### **Addendum No. 1**

## **Capitolo Playground Field Renovations and Site Improvements RFP**

### **Philadelphia Redevelopment Authority**

**Issue Date: August 24, 2021**

sketch no. LSK-4

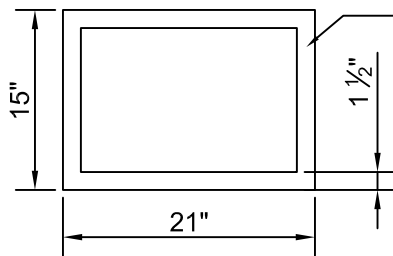
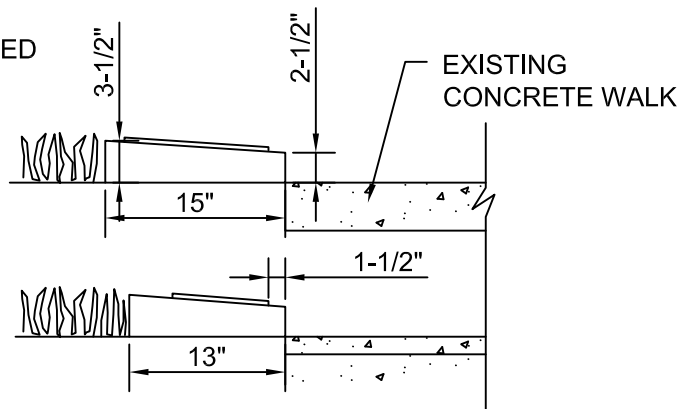
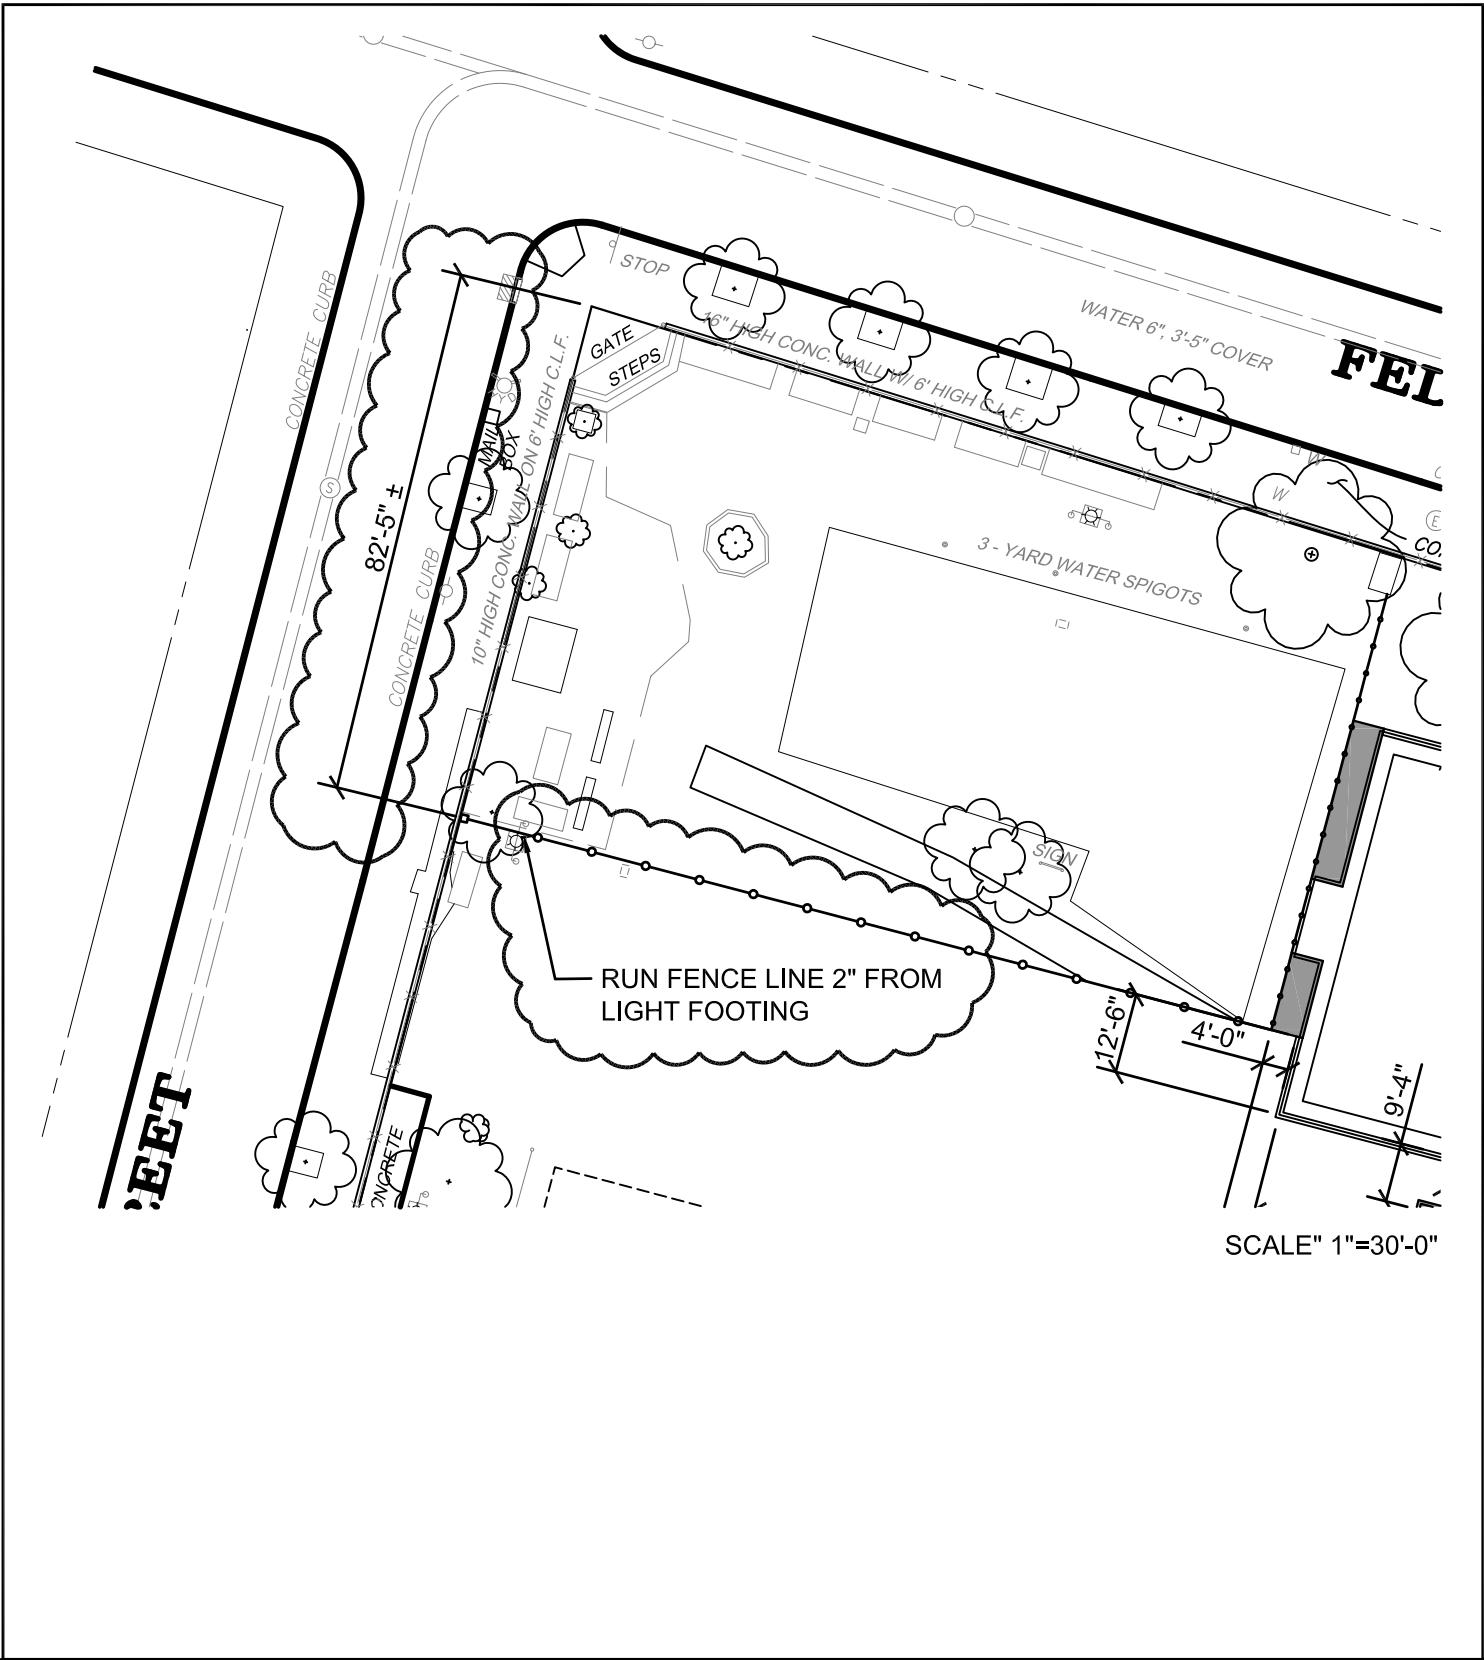
**3** New Locations for Relocated Plaques  
 L-103 SCALE: 1"=20'-0"

**8** Plaque Detail  
 L-501 SCALE: 3/4"=1'-0"

title Relocated Plaques Locations and Details
